DEVELOPMENT REVIEW COMMITTEE (DRC) COMMENT REPORT

PROJECT NAME: Mayla Cypress Creek

CASE NUMBER: UDP-S21045

REQUEST: Site Plan Level III Review: Proposed Alternative Design Solutions to the Uptown Master Plan Standards for Allocation of 312 Residential Flex Units and 32,993 Square Feet of Existing Office with an Associated Parking Reduction in the Uptown Project Area

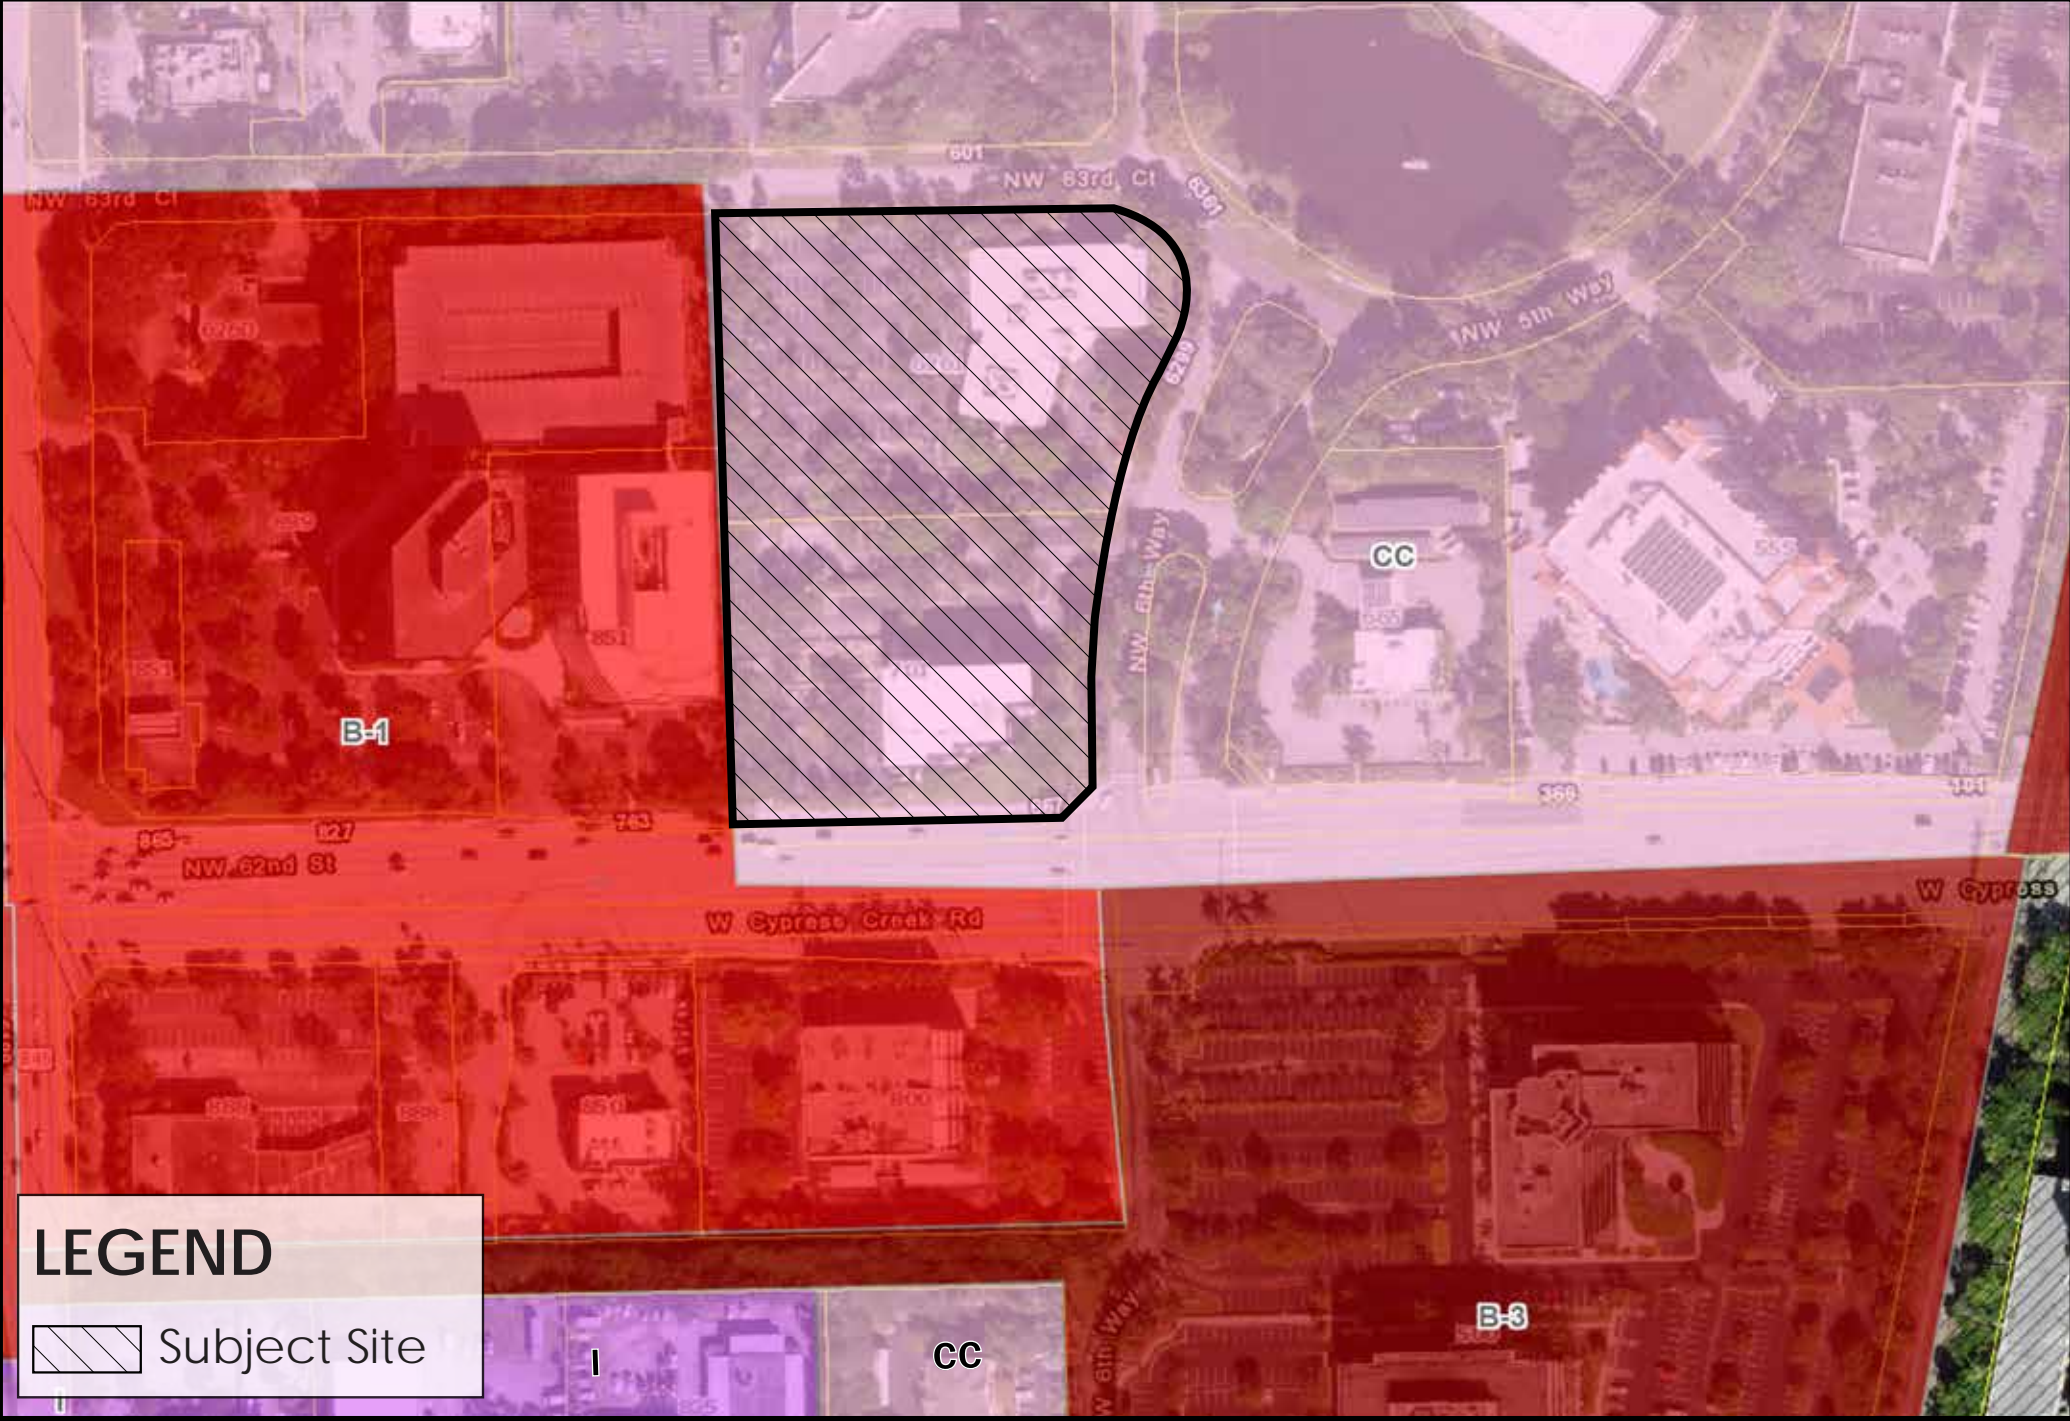
- e. Pursuant to ULDR, Section 47-37B.6.L, Sense of Place Elements. As proposed, the project does not appear to contain elements as described in this section of the ULDR. Provide more information and imagery of proposed sense of place elements for this project. Note that building illumination can be considered such an element.
- f. Pursuant to ULDR, Section 47-37B.6.I, Streetscape, as proposed, staff has identified an additional alternative design request the applicant will need for the development if the building stays as proposed. It does not appear the streetscapes meet the requirements of this section. Provide detailed cross sections for Cypress Creek Road, Northwest 6th Way, and NW 63rd Street, depicting the streetscape zones in relation to the building frontage. Refer to image below.
